DEVELOPMENT APPLICATION ASSESSMENT REPORT

Application Number:	DA2021/0088
----------------------------	-------------

Responsible Officer:	Thomas Prosser
Land to be developed (Address):	Lot 420 DP 19651, 28 Pacific Road PALM BEACH NSW 2108
Proposed Development:	Alterations and additions to a dwelling house including a swimming pool
Zoning:	E4 Environmental Living
Development Permissible:	Yes
Existing Use Rights:	No
Consent Authority:	Northern Beaches Council
Land and Environment Court Action:	No
Owner:	Danielle Cox
Applicant:	JJ Drafting

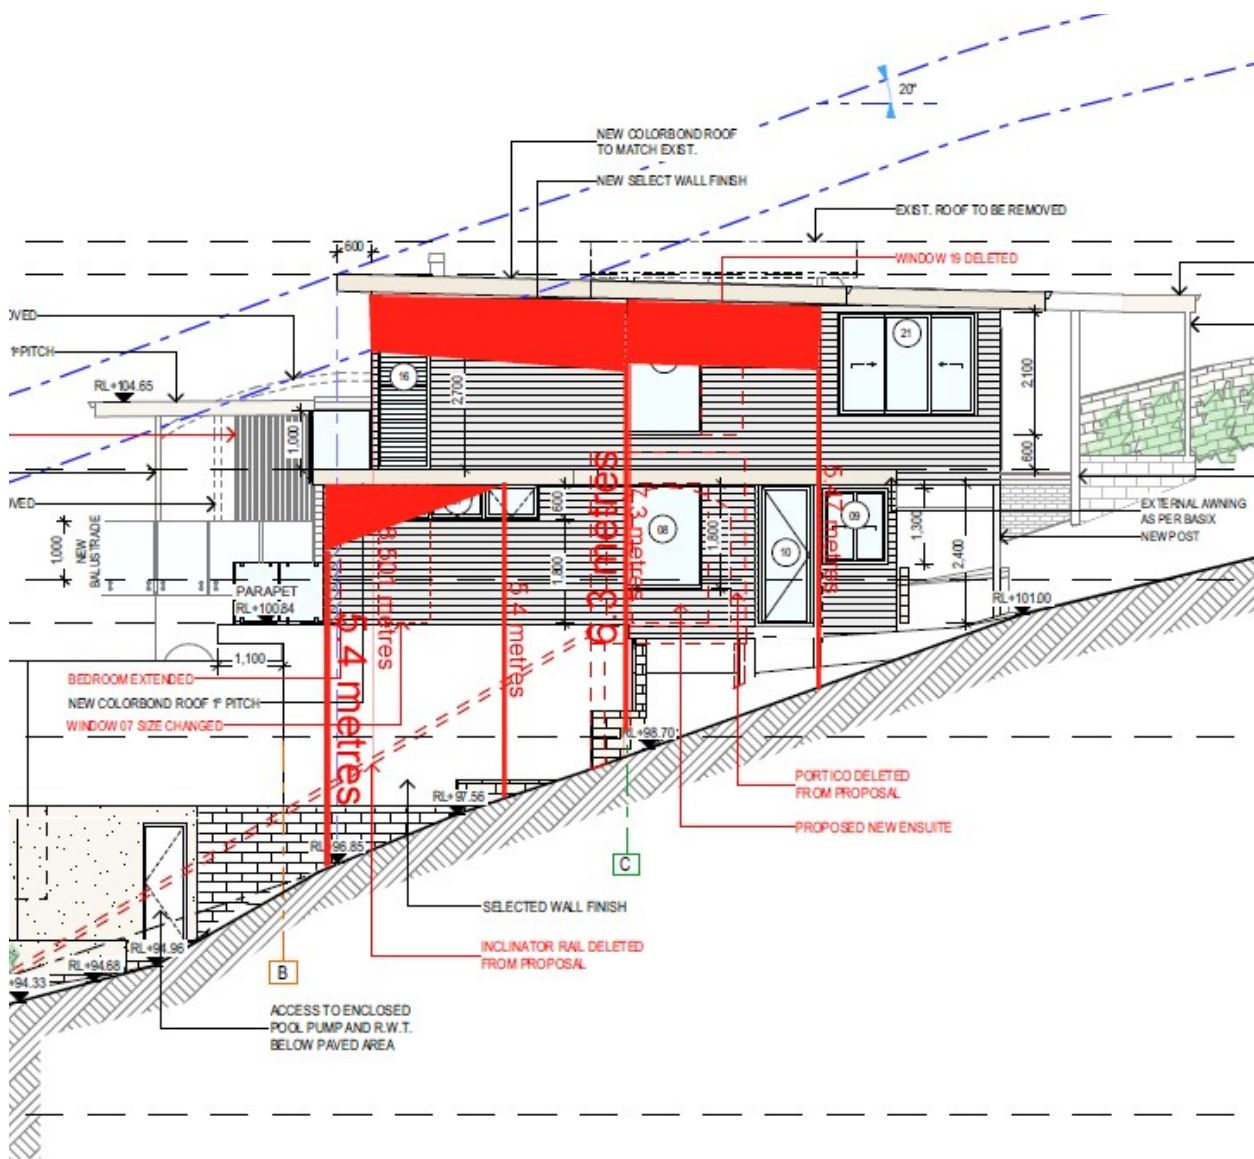
D12.8 Building envelope

Description of non-compliance

The proposed development does not comply with the requirement for side boundary envelope. In this regard, the proposal provides a non compliance at the north-west elevation (as demonstrated below).
